Subject: PROPELLER FLANGE FAILURES  
ON LYCOMING ENGINES AND  
LYCOMING SERVICE BULLETIN  
465 ISSUED ON 08-26-83.

Service Bulletin No. 465  
Engineering Aspects are  
FAA Approved

Redesigned Crankshaft for Aerobatic Engines.

Service Bulletin No. 465C  
(Supersedes Service Bulletin No. 465B)  
Engineering Aspects are  
FAA Approved

Figure 2. 10X Magnified View Showing Appearance of Area Cracked Due to  
Abnormal Loading Imposed on the Propeller Flange During Periods of  
Aerobatic Maneuvers.

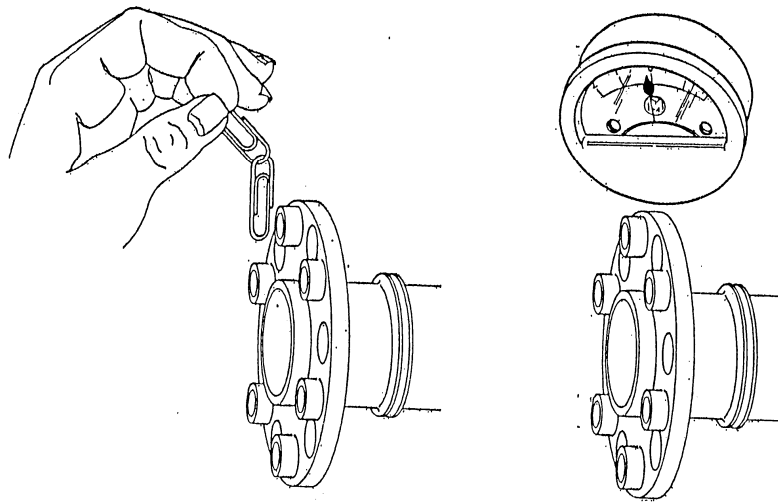
quate light. Inspect the entire flange area from the crankcase oil seal forward. Pay particular attention to the rear face and fillet radius of the propeller flange. See Figure 1. Figure 2 shows an area of the propeller flange with cracks developing.

6. Release switch and remove coil; inspect flange area as in Figure 1 & 2 for cracks using ultraviolet light.
